**RE: Addendum to the Contract Documents for the West High Service Pump Station
Bid No. ITB-4221**

**ADDENDUM NO. 2
TO
BID DOCUMENTS
FOR
WEST HIGH SERVICE PUMP STATION
FOR THE
CITY OF ANN ARBOR, MICHIGAN**

The following changes, additions, and/or deletions shall be made to the Bid Documents for the West High Service Pump Station Project for the City of Ann Arbor, Michigan, Bid No. ITB – 4221 on which bids were to be received, on or before, 10:00 A.M. Thursday, May 31, 2012.

SURGE TANK DETAIL
N.T.S.

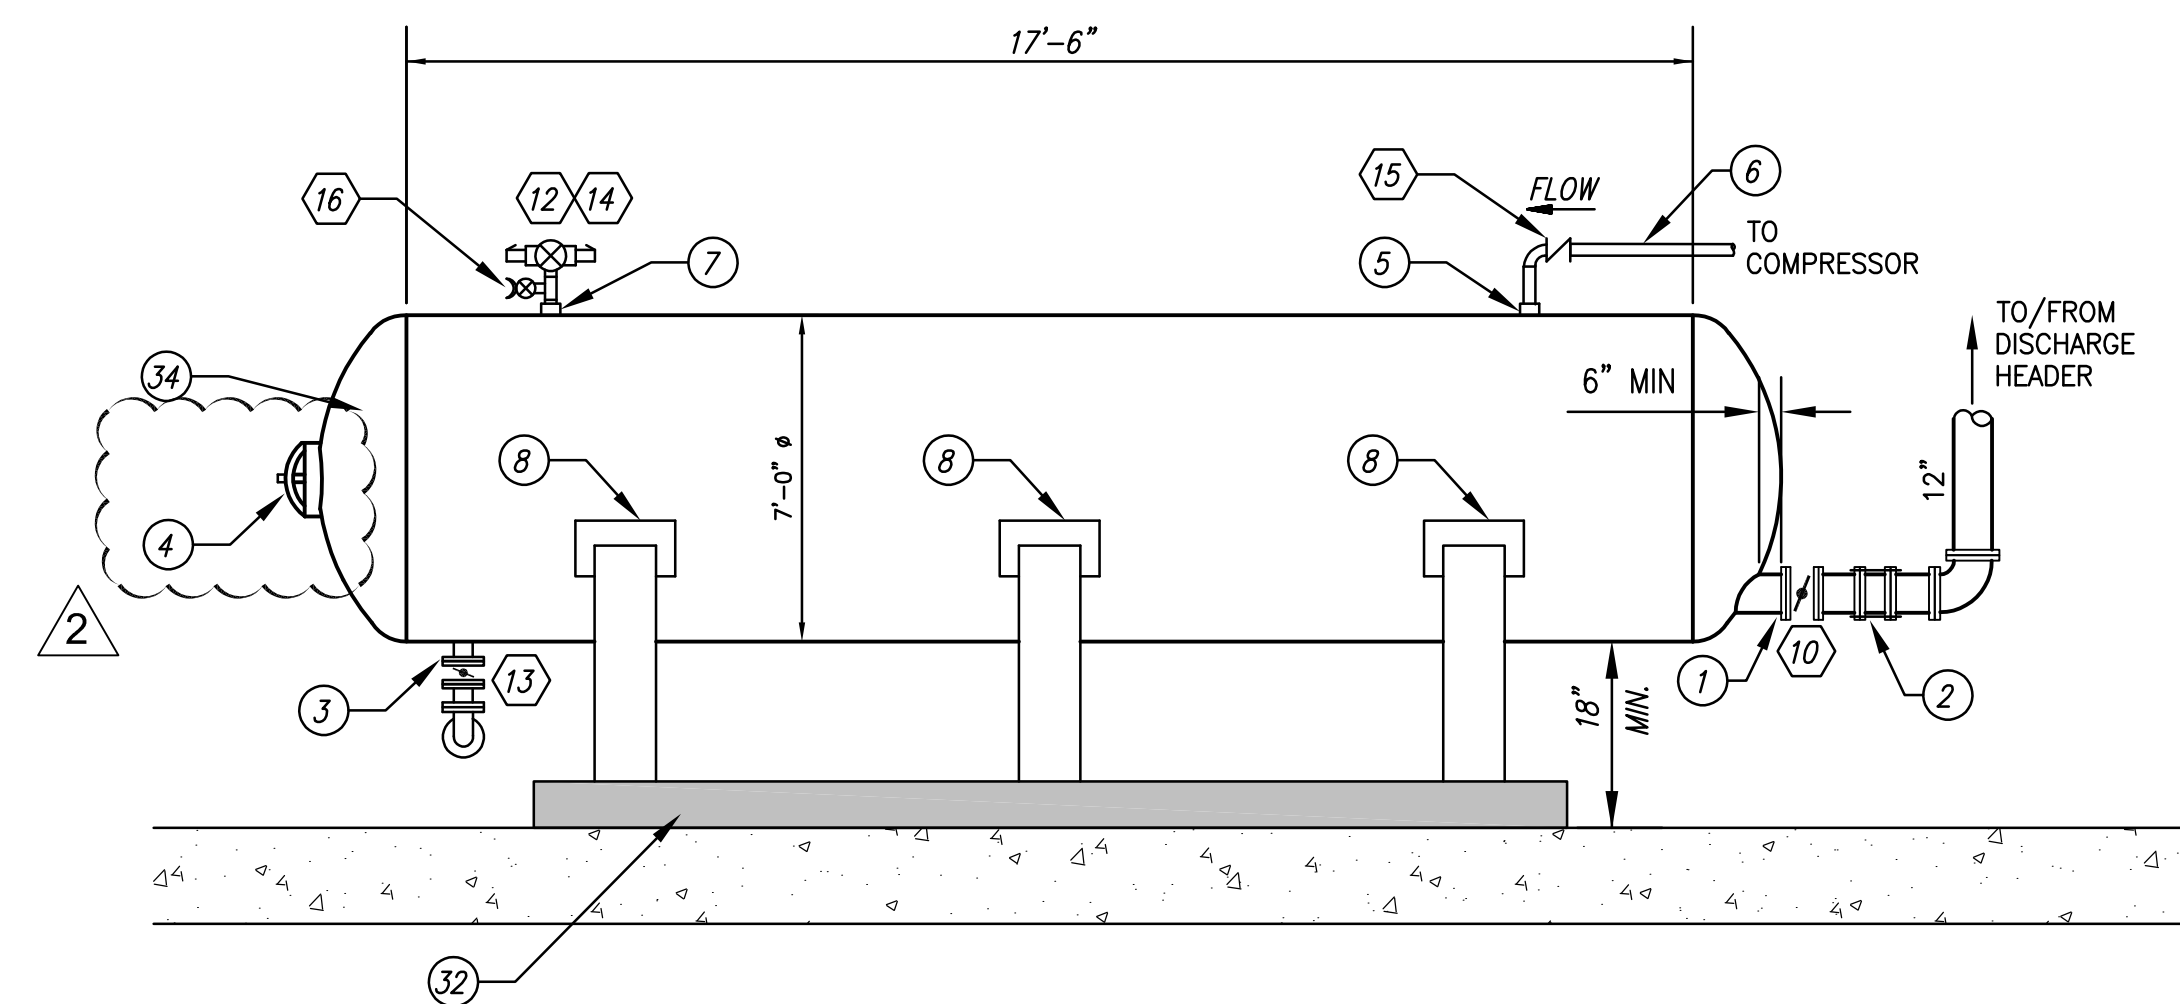
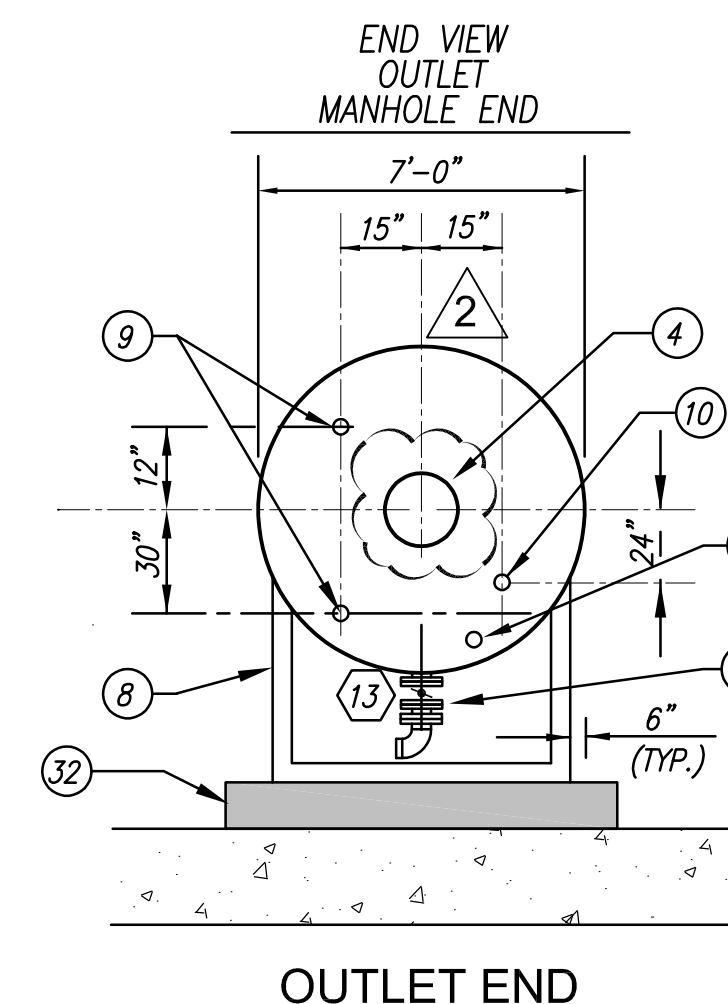
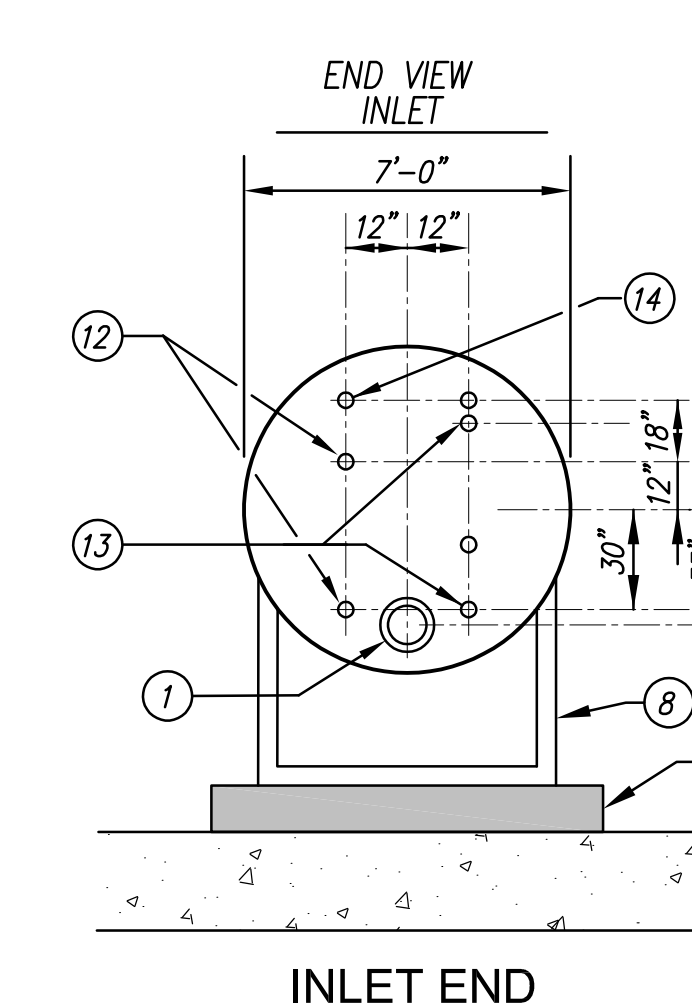
Revise Drawing P-107 to reflect a change in the surge tank manhole dimensions.

- A. **Yes, Tnemec Series 66 is an acceptable alternative shop primer on process piping.**
- Q. In the surge tank detail on Drawing P-107, the tank tangent length is shown as 17’-6” and the diameter is shown as 7’-0”. Specification Section 13200-Surge Tank indicates that the nominal tank capacity should be 5,000 gallons. Is a tank with a 16’-0” tangent length, 7’-0” diameter, and a capacity of 5,195 gallons acceptable?

- Q. The surge tank detail on Drawing P-107 requires three (3) tank supports. Can the tank be installed with only two (2) supports?
- A. **The three (3) saddle supports were designed to resist the buoyant forces resulting from a station flood (to elev. 990.0) with the tank empty. Two (2) saddles are acceptable, provided that a new design and supporting calculations for the anchoring of the tank to the foundation slab are prepared and submitted by a Professional Engineer licensed in the State of Michigan.**

- A. **Tank diameter may not change. Length may change so long as the volume requirements in the specifications are met.**
- Q. Specification Section 13200, Paragraph 3.1.C. states “The Contractor and fabricator shall plan to have the tank delivered to the site in sections and welded together at the project site for installation at the location indicated in the drawings.” Typically tanks of this type are built in a fabrication shop and delivered complete. Is it necessary to weld the tank in the field?

E-120 73 of 144 0

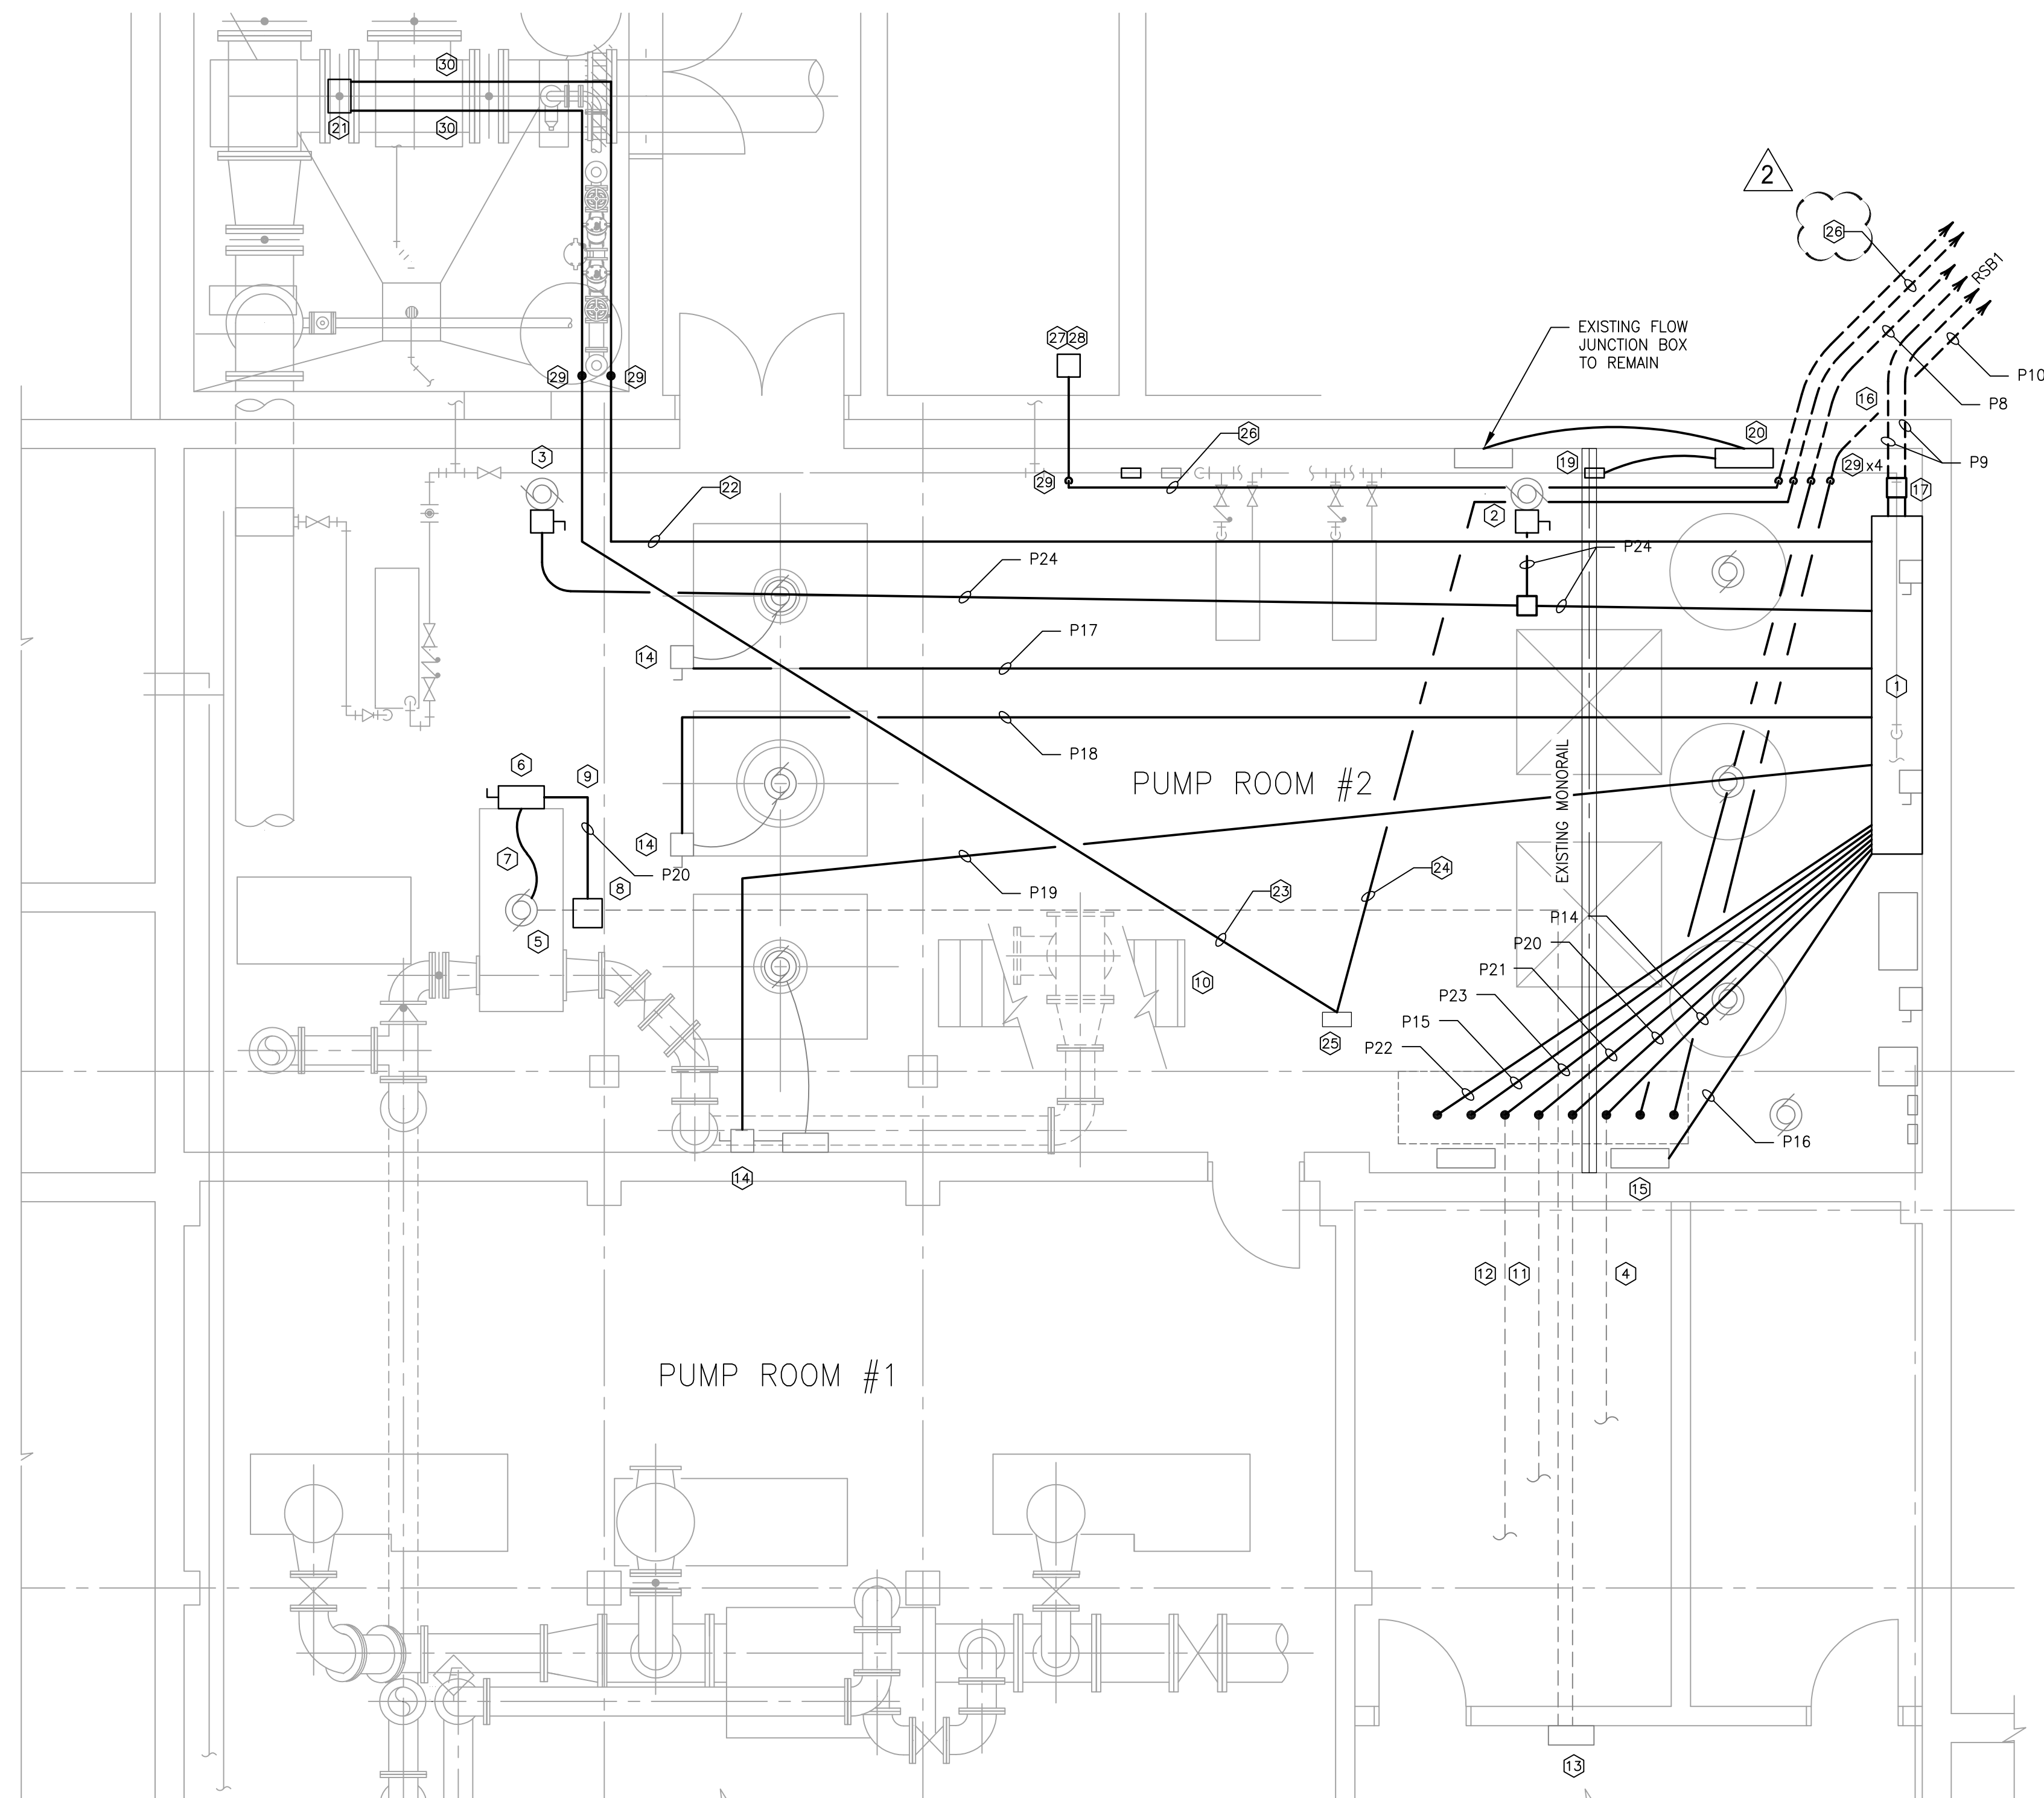
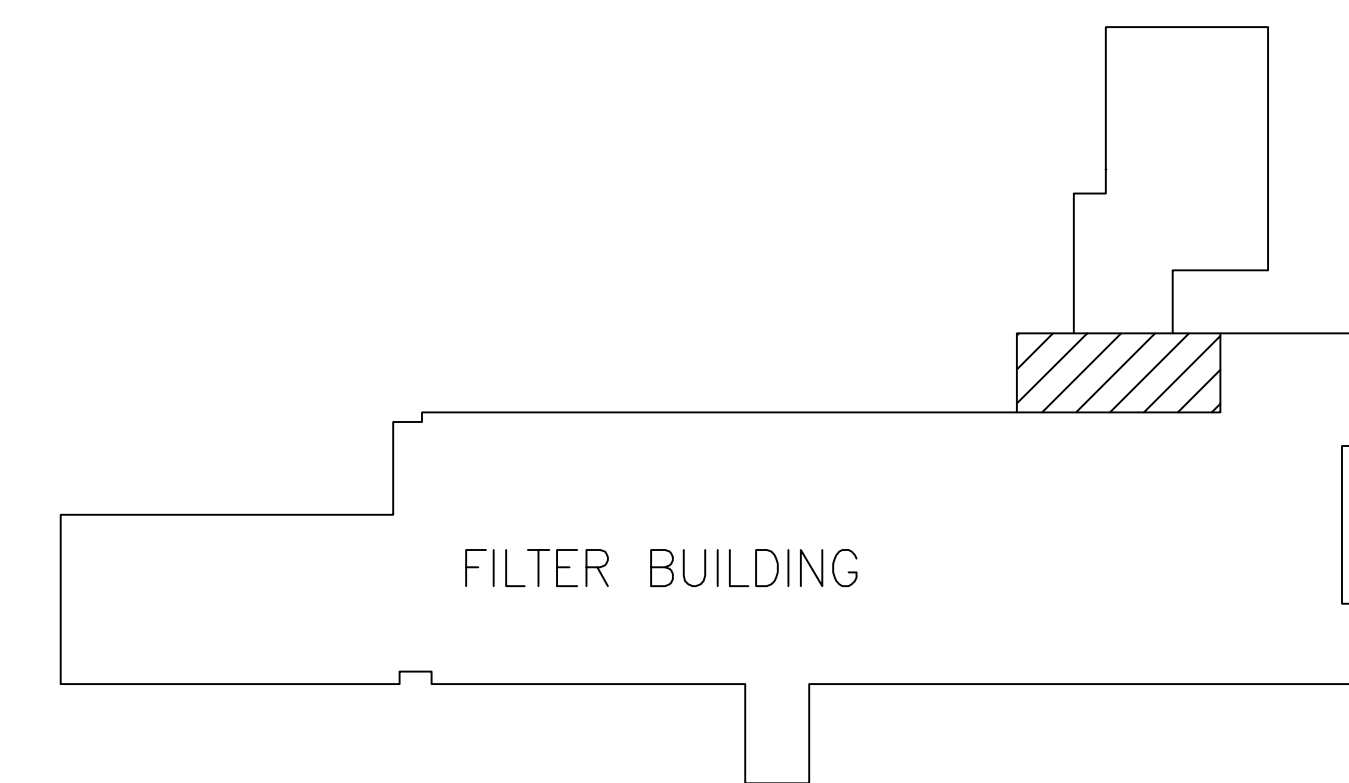
Revise Drawing E-120 to update conduit note.

- Q. Drawing E-120, Note 26 identifies a 4" conduit with 12 strand multi-mode fiber going from the existing fiber termination point. Is it correct to assume that this is Circuit P25 as shown on Drawing E-123?

- A. **Yes.**
- Q. Is the existing fire alarm system simplex?
- A. **Yes.**
